**ADDENDUM  
NO. 2**

**November 4, 2021**

**Portage Township School - Bid Package #2  
PHS Learning Lab, Elementary Schools Media Centers, and Office Renovation  
Portage IN, 46368**

## ADDENDUM NO. 2

ADDENDUM NO. 2	PORTAGE TOWNSHIP SCHOOLS LEARNING LAB, MEDIA CENTERS, OFFICE AND OFFICE PROJECT PORTAGE, INDIANA	
DATE	11/1/21	DRAWING SHT.
ADDENDUM DRAWING NO. OFFICE A8.0B	A8.0	<b>ALLIANCE</b> ARCHITECTS 929 Lincolnway East, Suite 200   South Bend, Indiana 46601

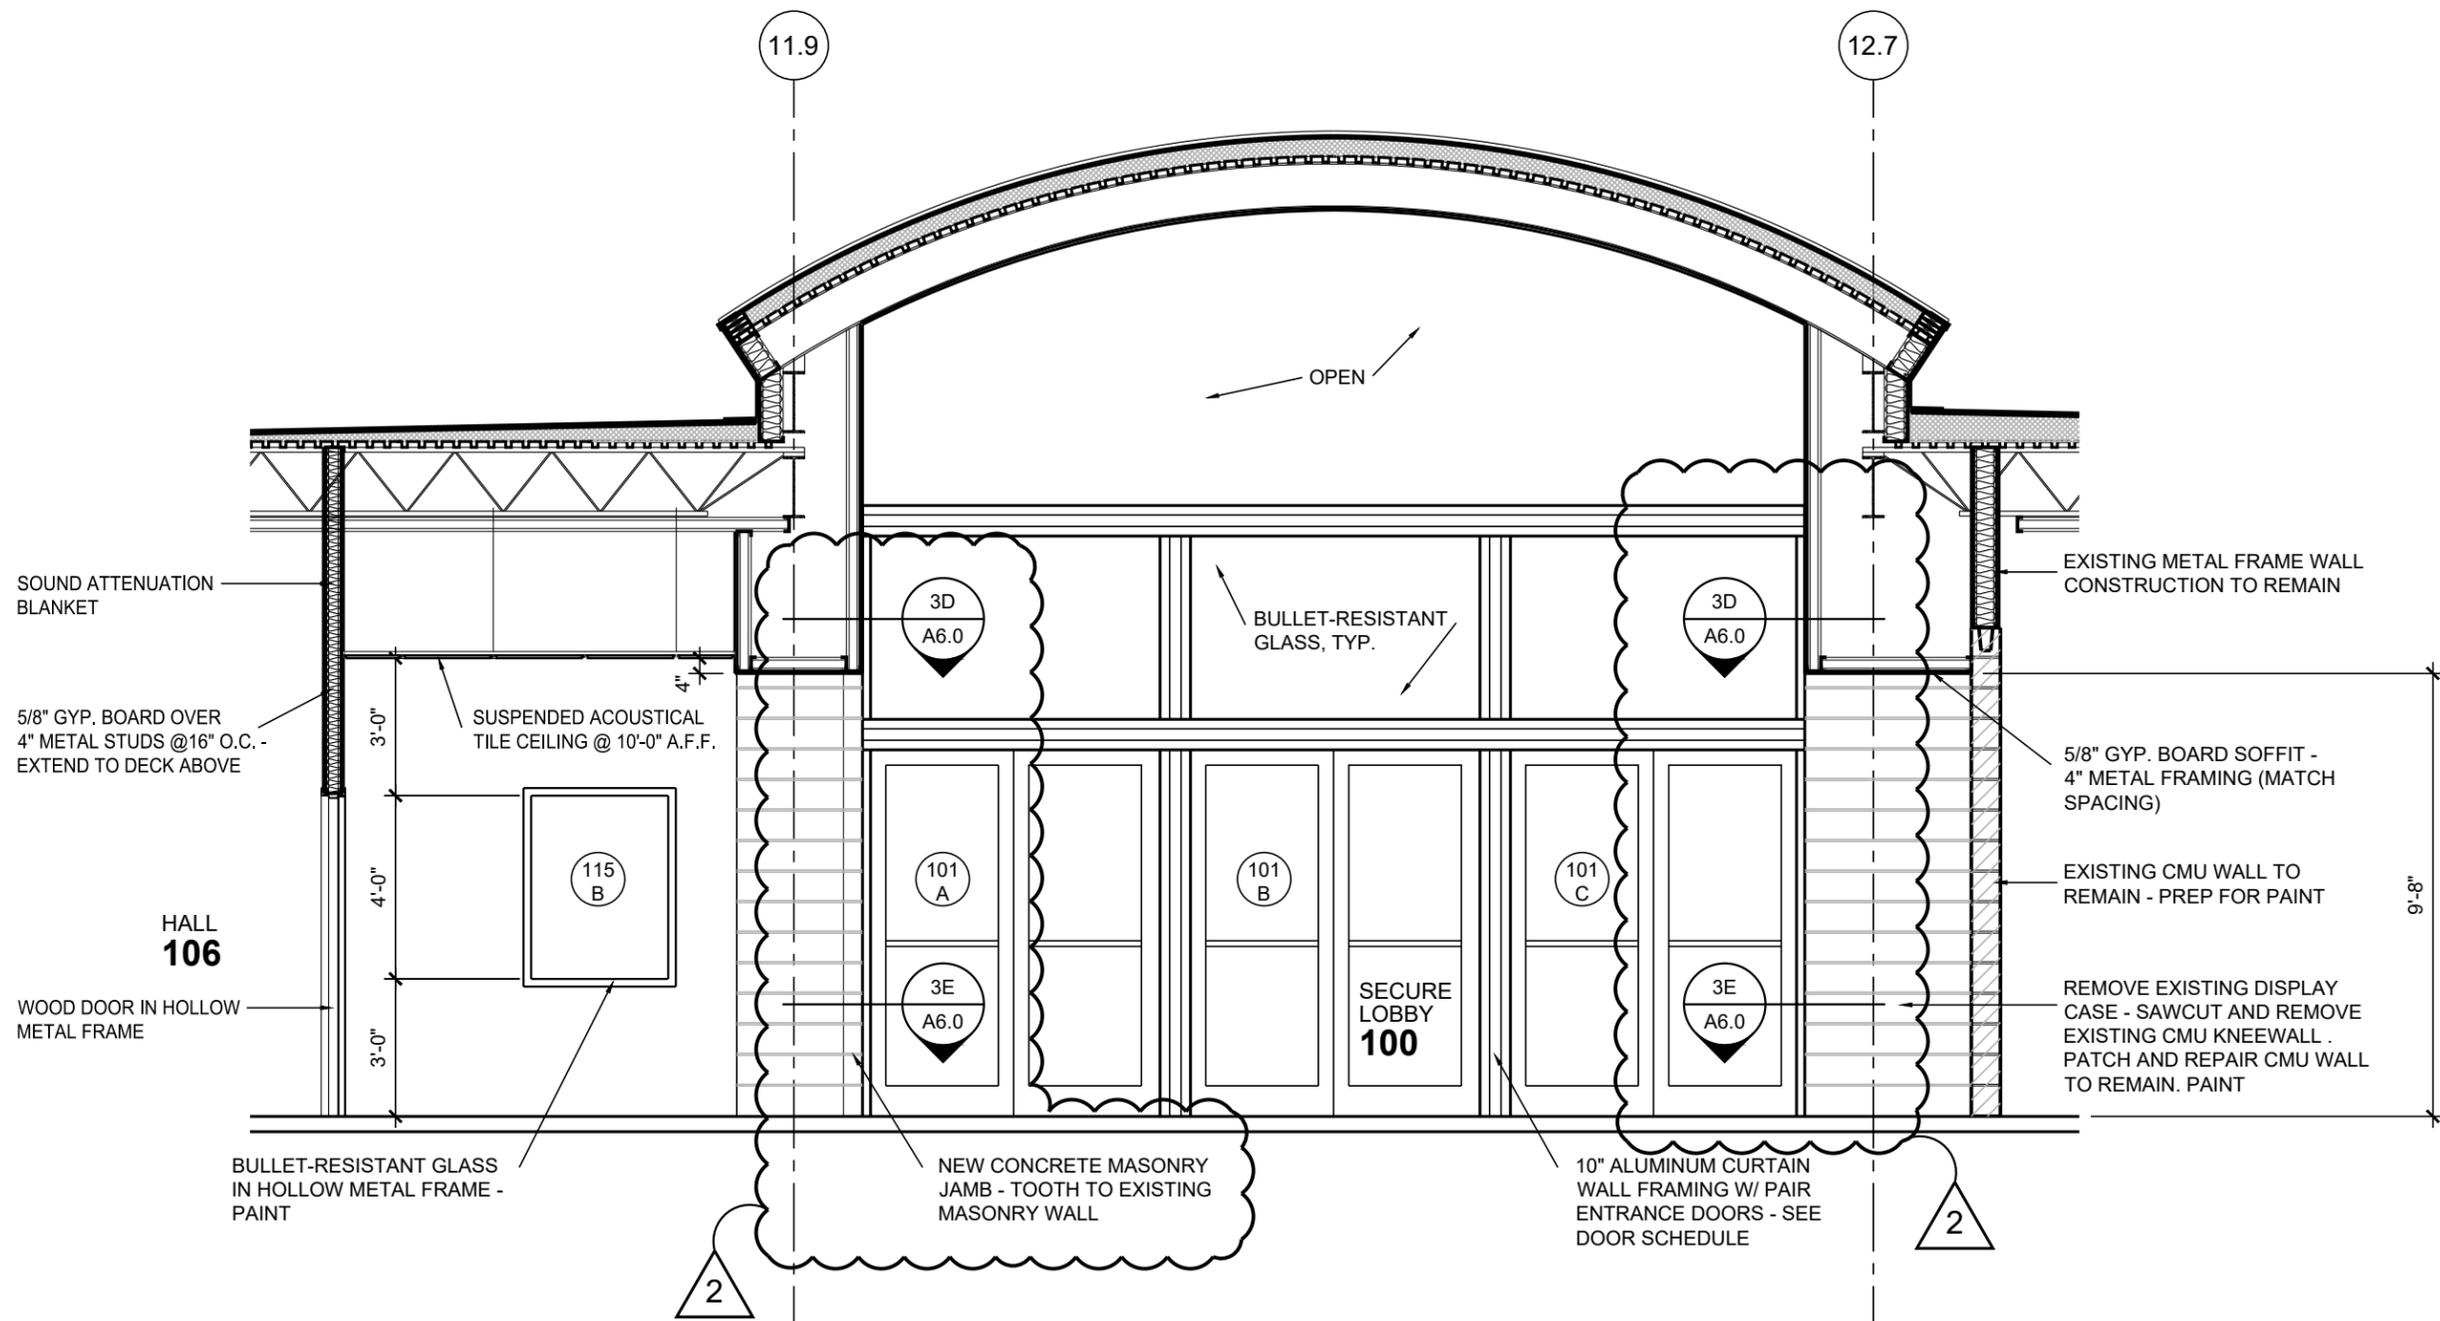
31. **DRAWINGS**; Sheet No. OFFICE A8.0:
- a. Add INTERIOR ELEVATION 9/A8.0 as shown on Addendum Drawing No. OFFICE A8.0A, dated 11/1/21.
- b. Revise INTERIOR ELEVATION 1/A8.0 as shown on Addendum Drawing No. OFFICE A8.0B, dated 11/1/21.

DATE: 11-01-21  
 PROJECT NO.: 212562  
 CAD NAME: OFFICE E2.0  
 SHEET NO.:  
 OFFICE E2.0-11-01-21

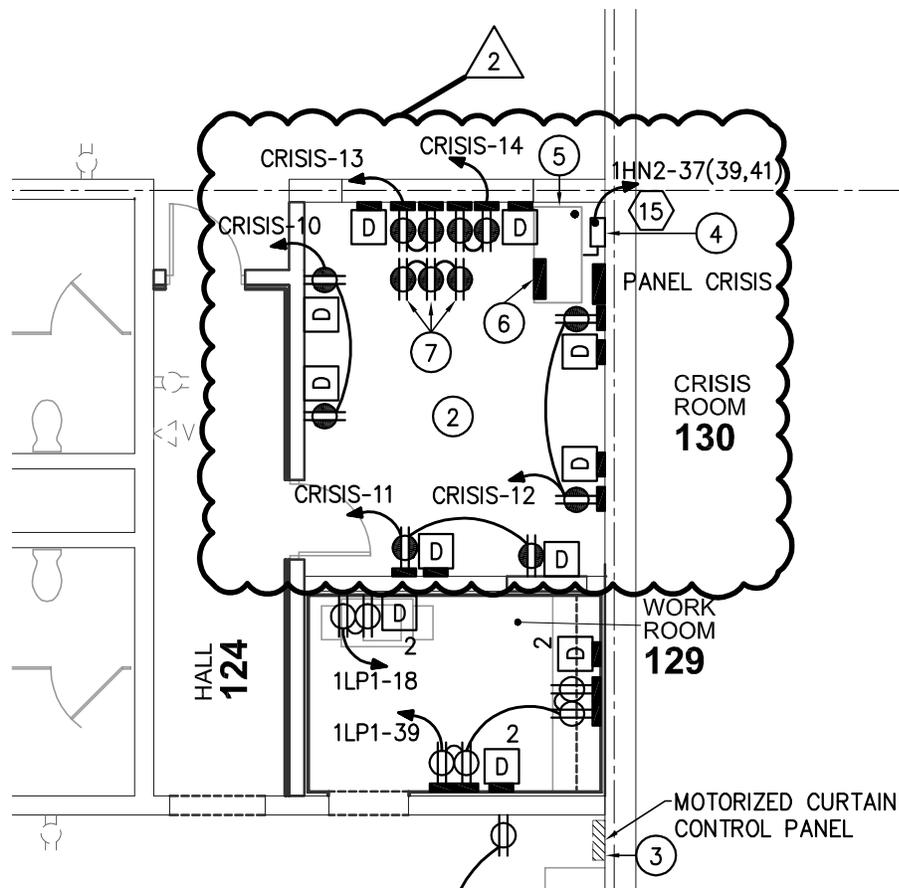
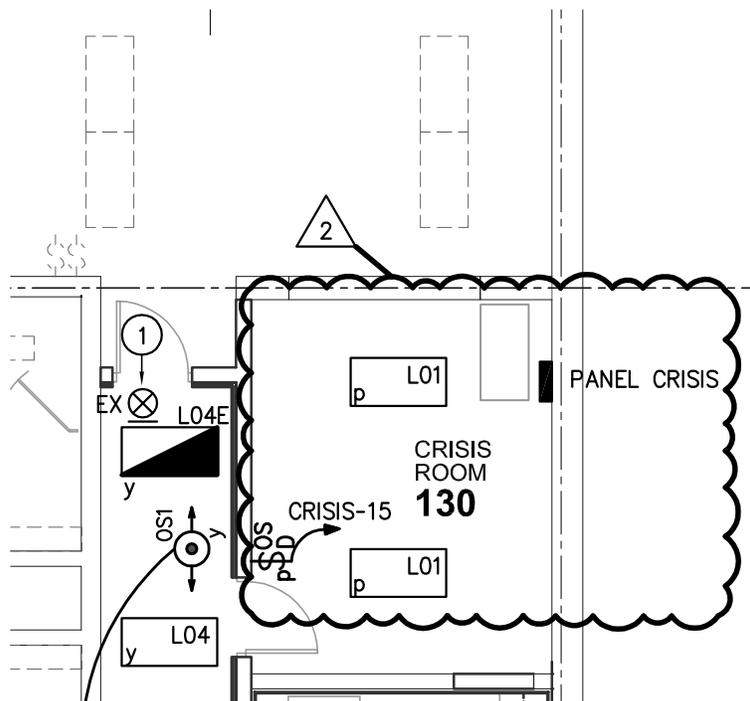
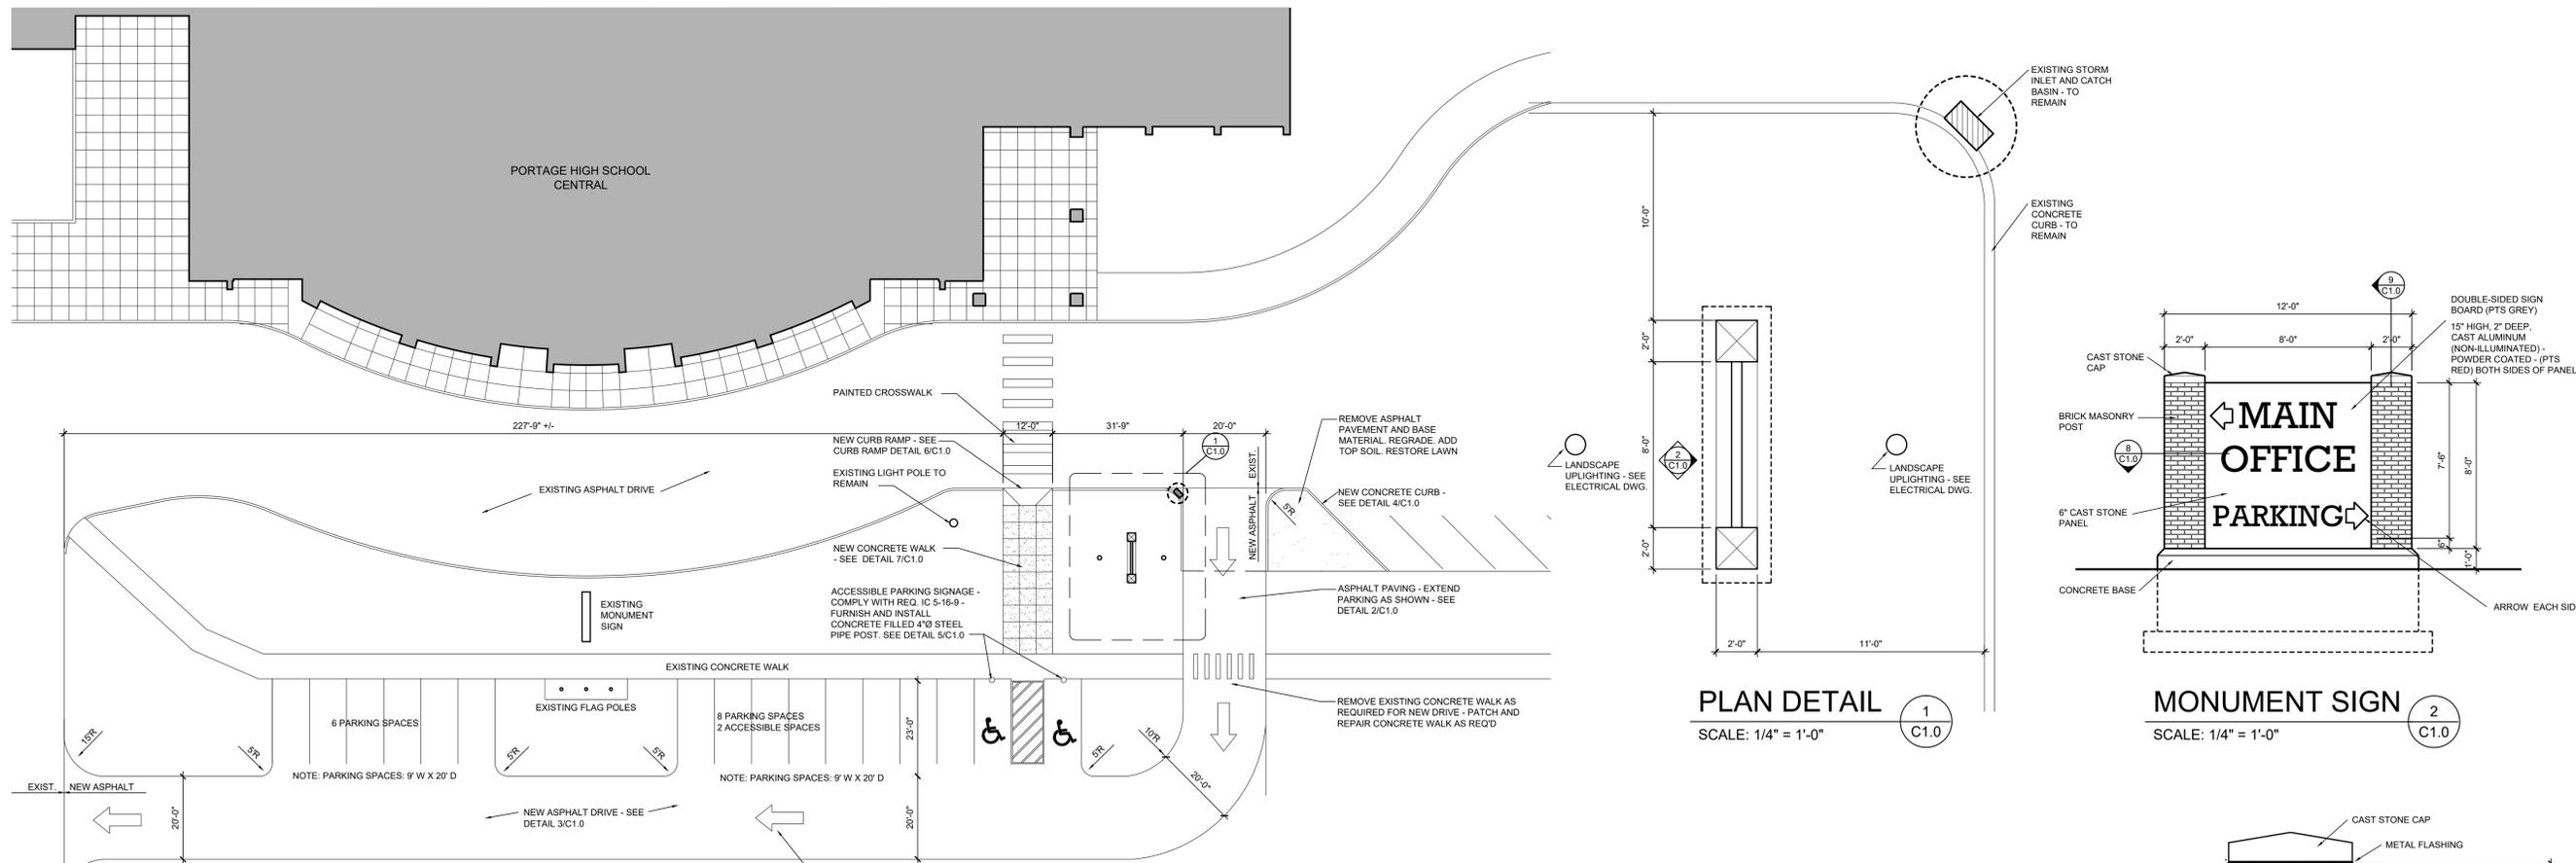
- b. Revise Electrical Lighting Plan for addition of Crisis Room 130 lighting distribution as shown on Addendum Drawing OFFICE E2.0, dated 11/1/21.
35. **DRAWINGS**; Sheet No. OFFICE E3.0: By way of clarification, the Fire Alarm Control Panel for this area is located in Boiler Room N105, approximately 230' west of door 101A.

SUBSET  
**OFFICE**  
SHEET NO.  
**C1.0**

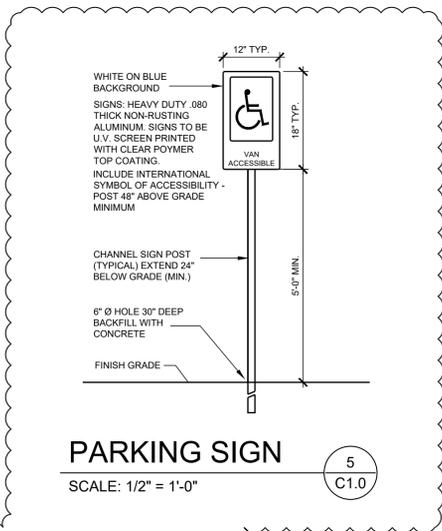
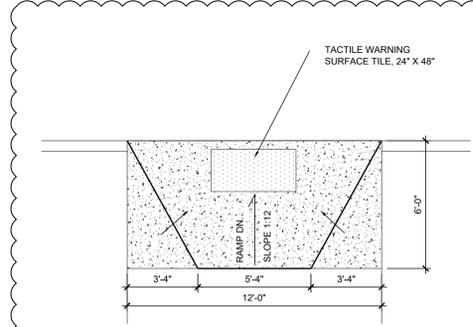
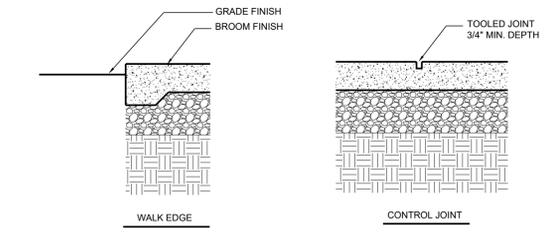
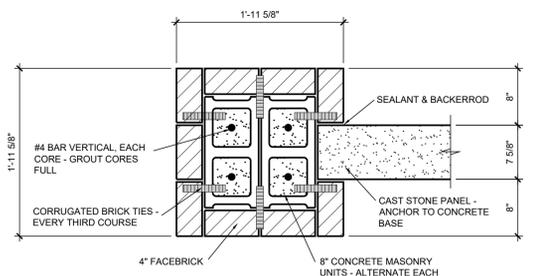
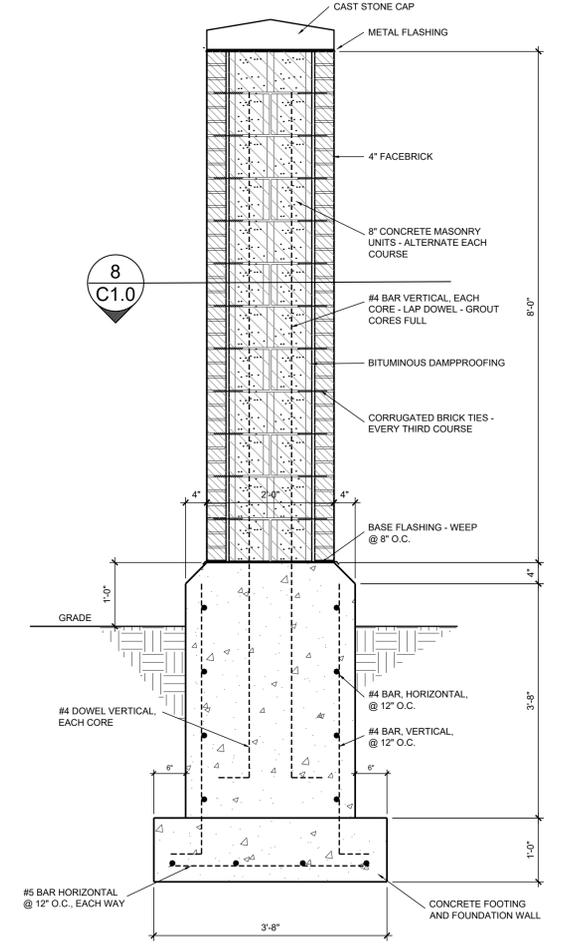
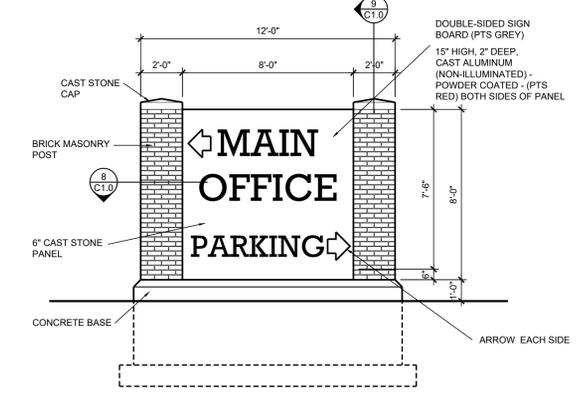
27. **DRAWINGS**; Sheet No. OFFICE C1.0: Replace this sheet in its entirety. Note the expansion of the work shown on the Partial Site Plan as well as revisions to and the addition of several details.
